# **COUNCIL ASSESSMENT REPORT**

Panel Reference	PPSSCC-333		
DA Number	1021/2022/JPZ		
LGA	Hills Shire Council		
Proposed Development	Small lot housing development and subdivision creating 48 community title residential lots/ dwellings, one association lot and one road widening lot including new road, demolition, contamination remediation and dam dewatering accompanied by an application to vary a		
	development standard (maximum building height)		
Street Address	Lot 42 DP 662070 – 65 Windsor Road, Norwest Lot 1 DP 518740 – 67 Windsor Road, Norwest		
Applicant	Landen Property Pty Ltd		
Consultant/s	Orion Group – Planner Orion Group – Engineer Orion Group – Survey KFW Infrastructure Professionals – Survey A&N Design Group – Architects Conzept Landscape Architects – Landscape Architect MCG Quantity Surveyors – Quantity Surveyor Geotest Services – Contamination Remediation Geotest Services – Geotechnical McCardle Cultural Heritage – Aboriginal Heritage Eco Logical Australia – Ecology Axiom Arbor Tree Services – Arborist Amber Organisation – Traffic Day Design Pty Ltd – Acoustics

Clause 4.3 Height of buildings	
	R3 Medium Density Residential	
	SP2 Infrastructure	
Summary of key	Traffi

## **ATTACHMENT 6 - ELEVATIONS**

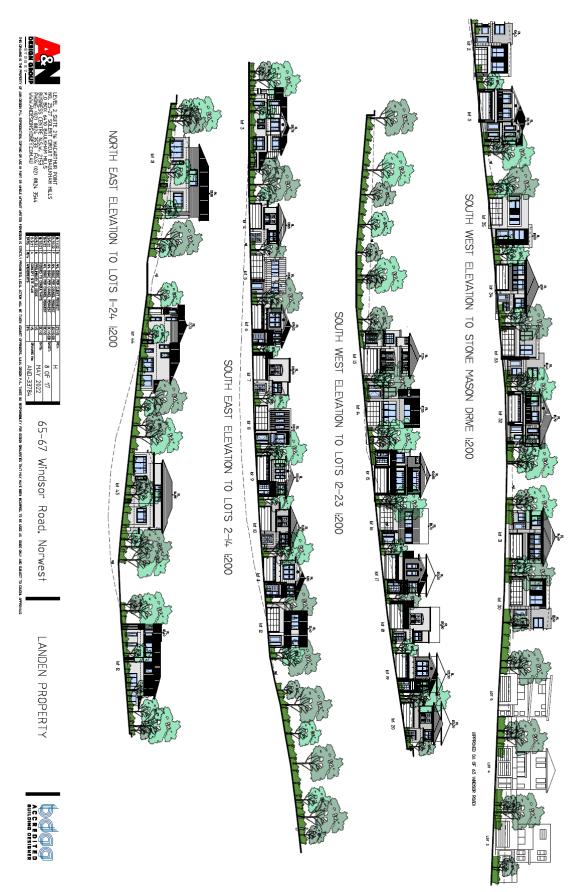
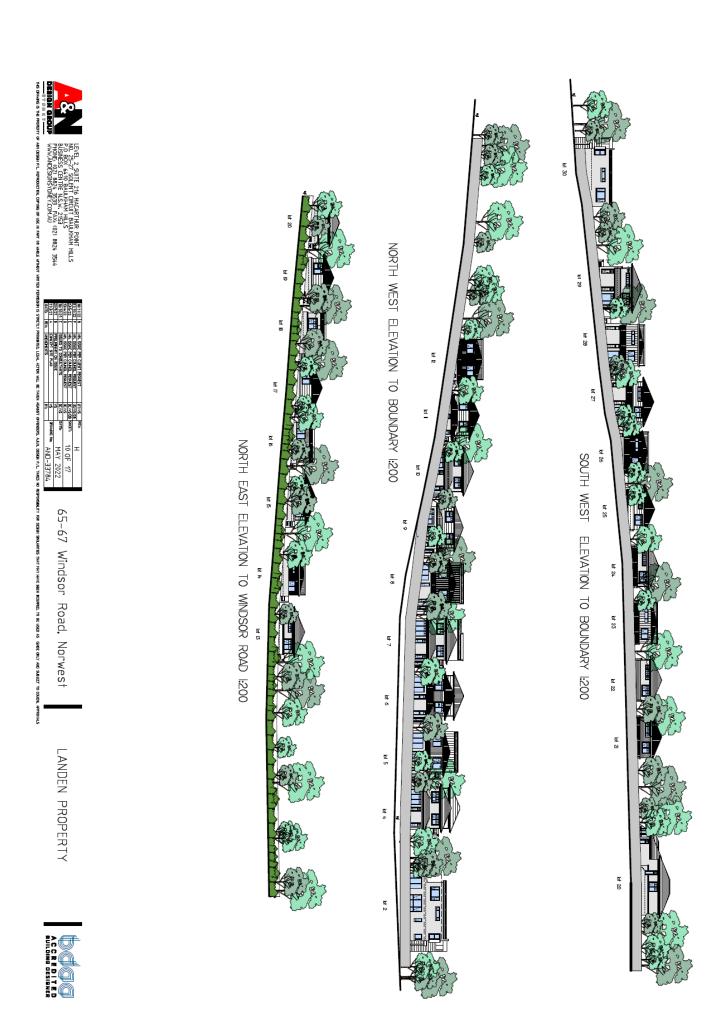
- The floor plans and elevation drawings are inconsistent with respect to the treatment of the walls around the alfresco areas. Refer to units two and three for examples of this. The floor plans suggest the side and back are open to the POS however the elevations show them as enclosed areas/ additional rooms which is not supported. In the meeting that was held on 17 March 2023, the applicant confirmed that the alfresco areas are open and this will be made clearer on the architectural plans.

- A schedule of materials and finishes has not been provided and is required. The elevation drawings defer to the streetscape plans for full details however they include little detail relating to this.

## **ATTACHMENT 7 - SECTIONS**

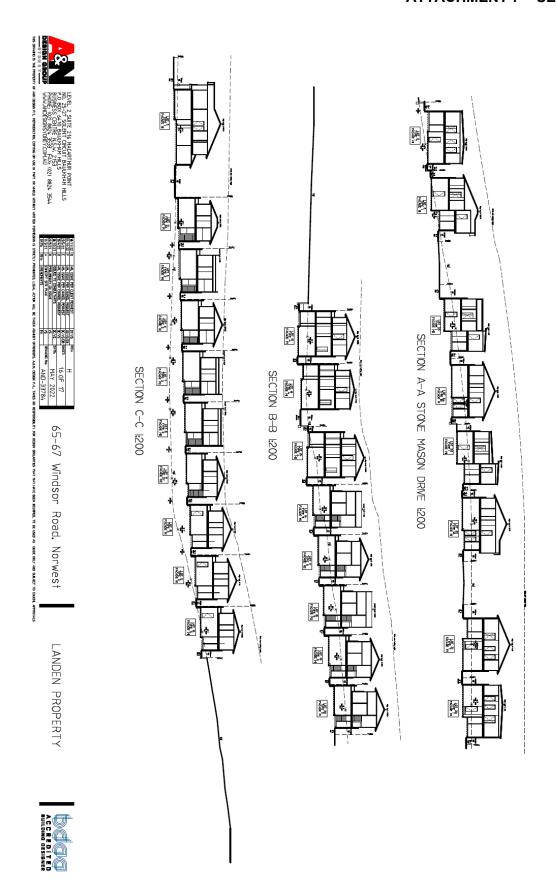
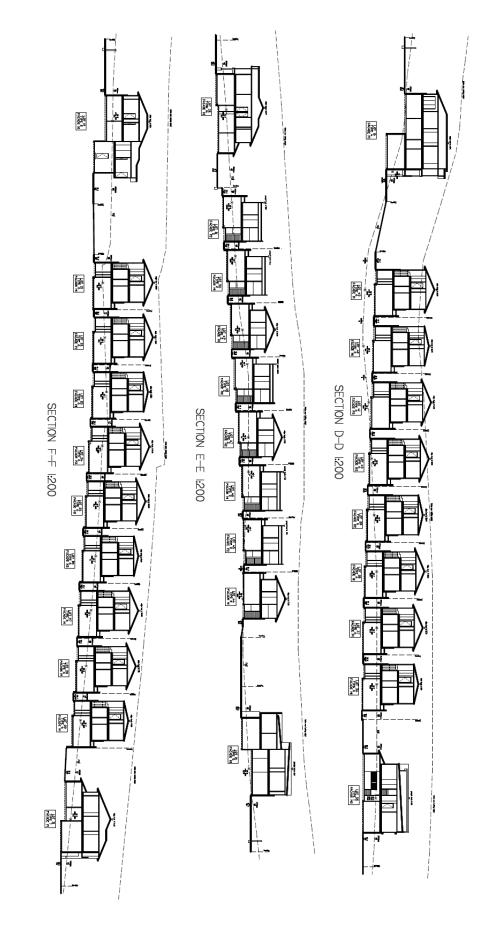
It was previously requested that section elevations for all dwellings be provided. This has not been submitted as part of the amended documentation. One section elevation has been proposed showing four dwellings only, with two dwellings both being labelled as dwelling "24". Furthermore, there is no line on the architectural plan indicating the location of this section. As previously requested, please provide sections detailing the levels for all dwellings. The engineering plans include more site sections however between the two we still do not have enough information to properly assess the impacts. For example, the sections included with the engineering plans suggest the wall along the south-eastern side boundary varies in height up to a maximum of 2.4m. Similarly, the wall along the north-western boundary varies in height up to a maximum of 1.8m. Based on the plans submitted it is unclear where these maximum heights are located or what the impacts are (noting too there is a development consent over the property to the south-east that has to be considered here as below).

## **ATTACHMENT 8 - LANDSCAPE PLANS**

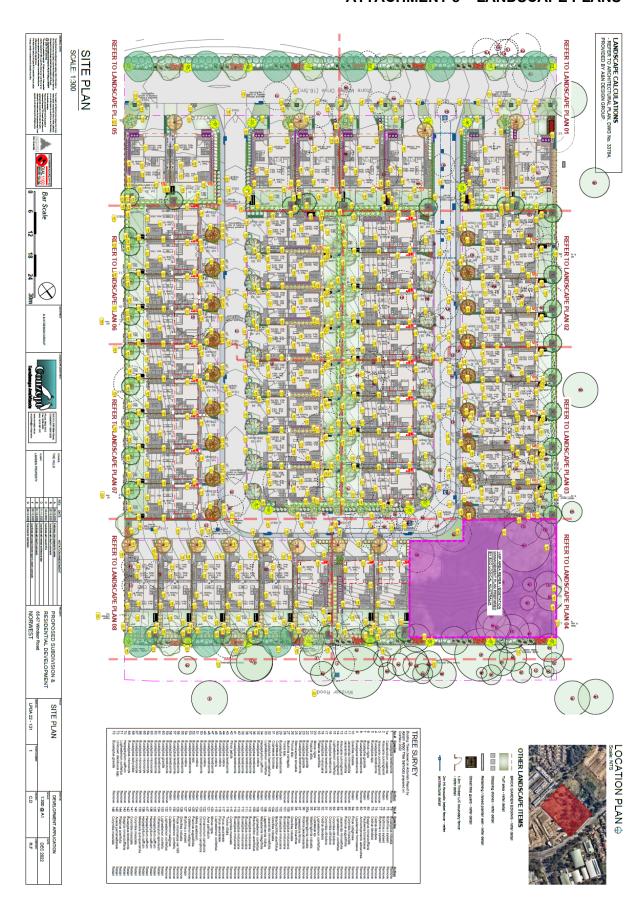
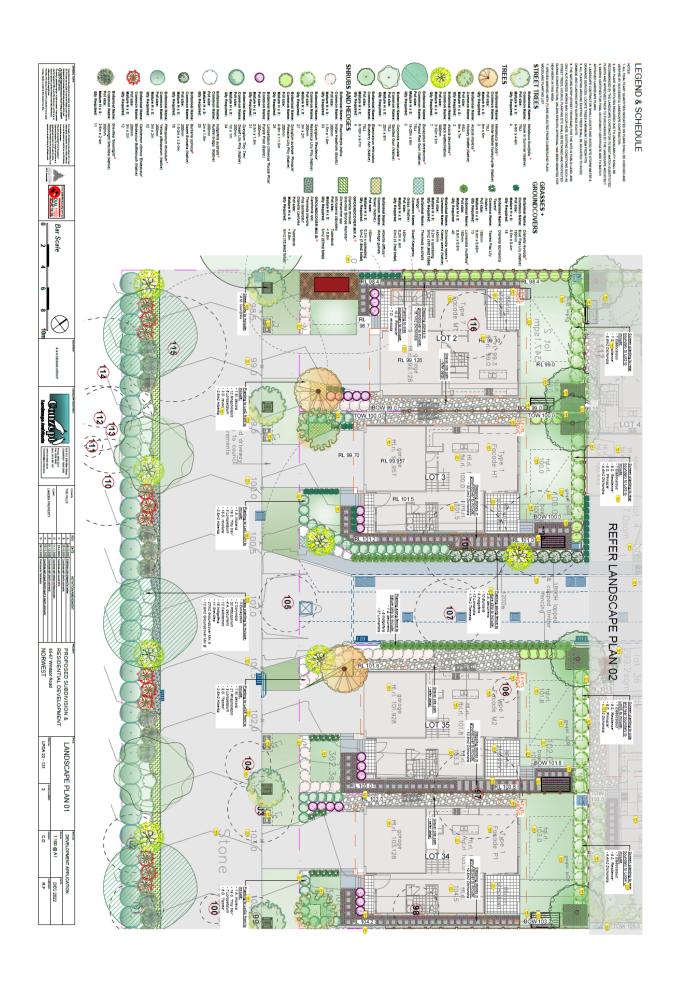
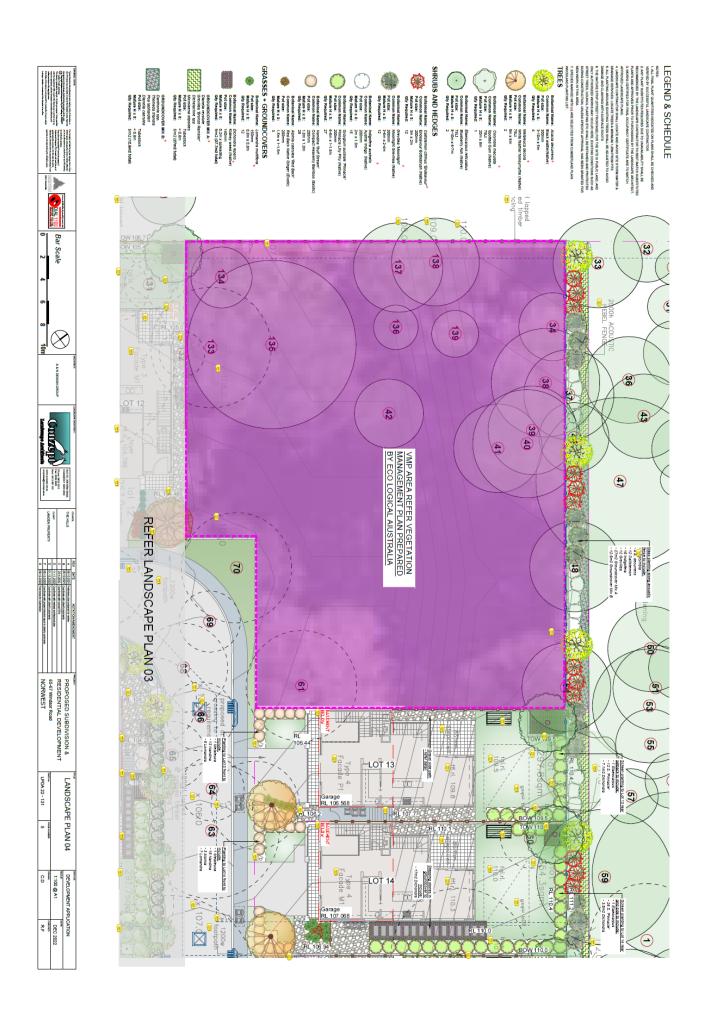
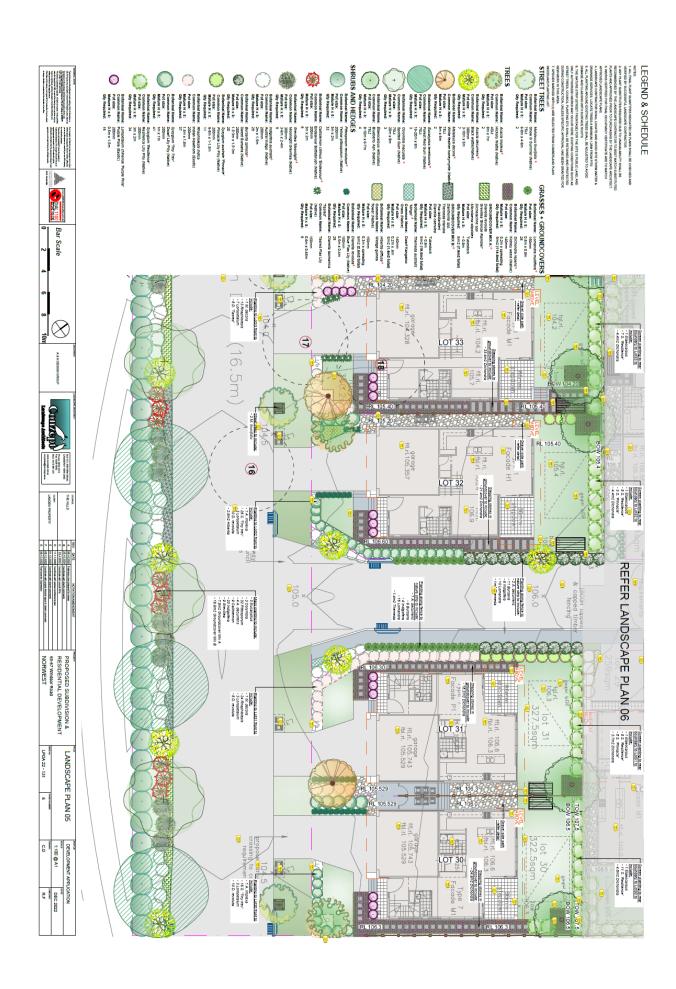
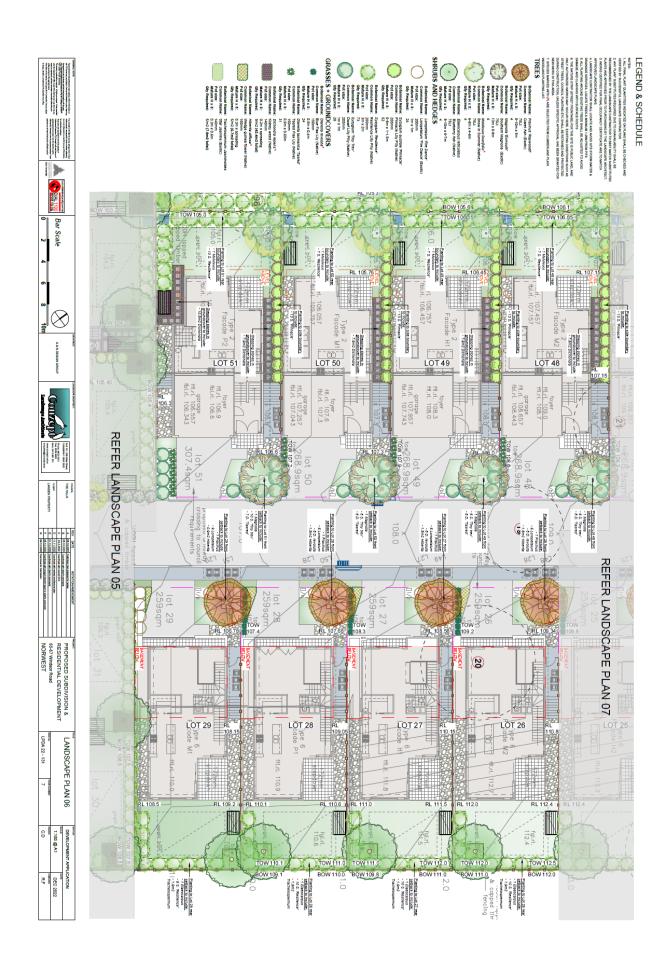
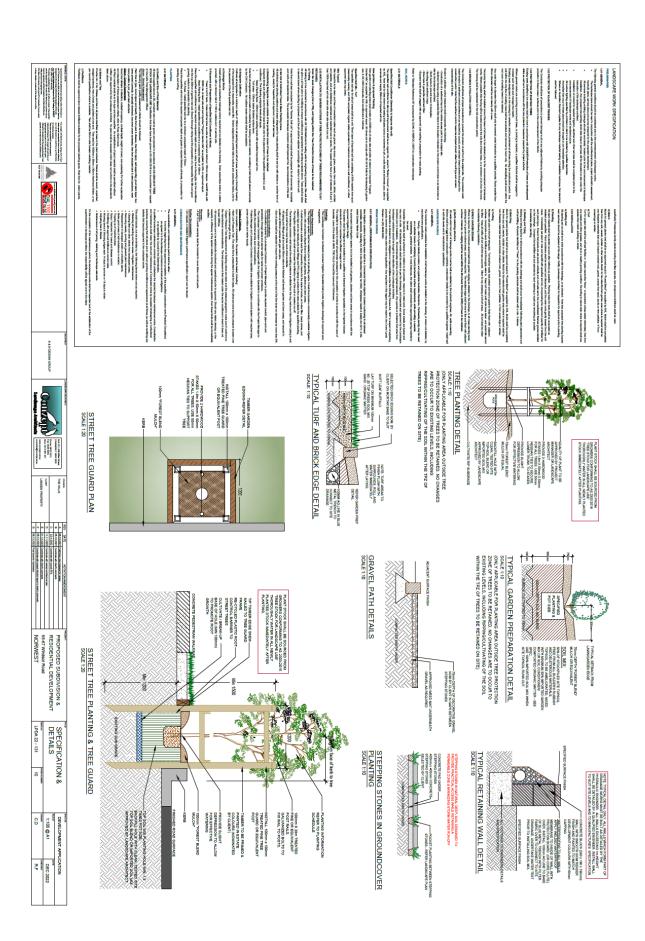
- The landscape plan shows a set of stairs between the alfresco and POS for unit 2. The architectural plans do not. Based on the levels noted on both plans there is no level difference/ need for stairs here? If there is a level difference the rear of this unit should be stepped to sit level with the POS.

- 1. The landscape area calculations remain unclear. Please provide a landscape area diagram which clearly indicates what has been included as landscape area for the site. A minimum of 40% of the whole site is to be landscaped. All landscaped areas are to have a minimum width of 2m. Hard surface within POS areas can be included so long as the hard stand within the lot does not exceed 15% of the lot area:

- **2.** As per previous comments, please indicate terraced walls where walls are over approx 1m to resolve the landscape levels and provide as much visual amenity as possible;

- 3. Walls must be clearly located on all plans, such as those which are required between lots and to boundaries, and additional walls provided where required to create usable spaces. Retaining walls remain insufficiently detailed. High blank walls remain proposed such as the following between Lot 36 and Lot 34. See levels below indicating a 1.8m wall which would have a 1.8m fence over, equating to a combined wall/barrier of 3.6m. As per previous comments, it is also noted that the shade that would be generated into the POS area (falls to the south) of lot 34 has not been taken into consideration of the shadow diagrams which have not modelled the fencing or retaining walls;

- 4. Retaining walls continue to be lacking detail, and not be terraced to minimise amenity impacts or located to minimise impacts on trees. The retaining wall plan/ Interface plan provide spot maximum height of walls, however, does clearly indicated the wall heights across the site, or the proposed visual impact of boundary walls on neighbouring properties such as for the proposed fill to the POS areas of Lot 09 and others which interface with RMB 69 Windsor Road. Please note that boundary fencing has not been indicated on sections, and therefore the resultant height of the barrier is the height of the wall (between 1.5m-2m according to the site regrading plan) plus a 1.8m POS fence over;

## ATTACHMENT 9 - SHADOW DIAGRAMS

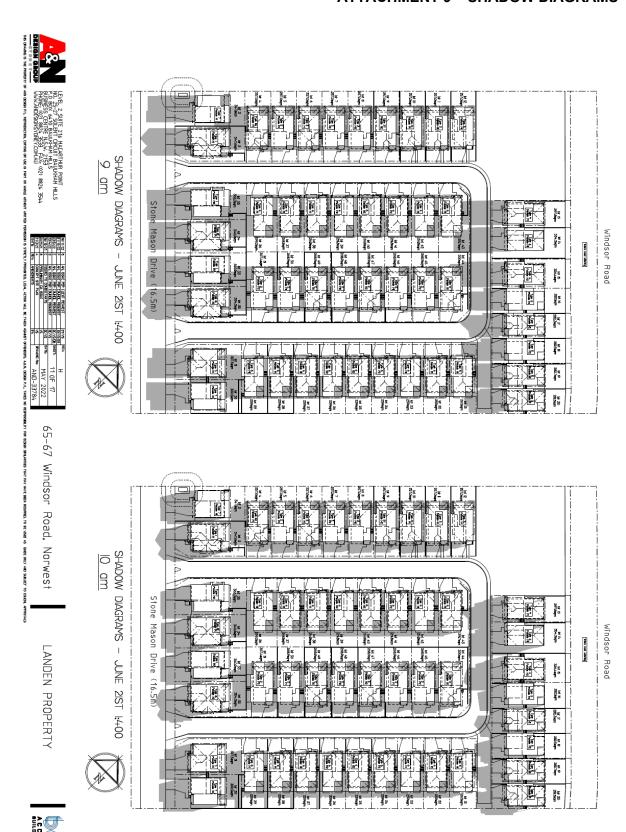
- Retaining walls and fencing had not been considered with the shadow diagrams. We also raised concern with the fact some units were noted as complying when the diagrams showed otherwise. There are still several lots which show the POS is overshadowed for hours where the table states that it is compliant as follows. Whilst the information provided demonstrates that most of the units achieve a minimum of two hours the table and the plans must be amended to address the retaining walls/ fencing and the table updated accordingly.

- At least 50% of the private open space within the subject property shall receive direct sunlight for a minimum of 2 hours	were noted as complying when the diagrams showed otherwise. There are still several lots which show the POS is overshadowed for hours where the table states

-	between 9am and 3pm on 21 June. Collapsible or permanent clothes drying device is to be provided within private open space areas and located to maximise	that it is compliant as follows. Whilst the information provided demonstrates that most of the units achieve a minimum of two hours the table and the plans must be amended to address the retaining walls/ fencing and the table updated accordingly.
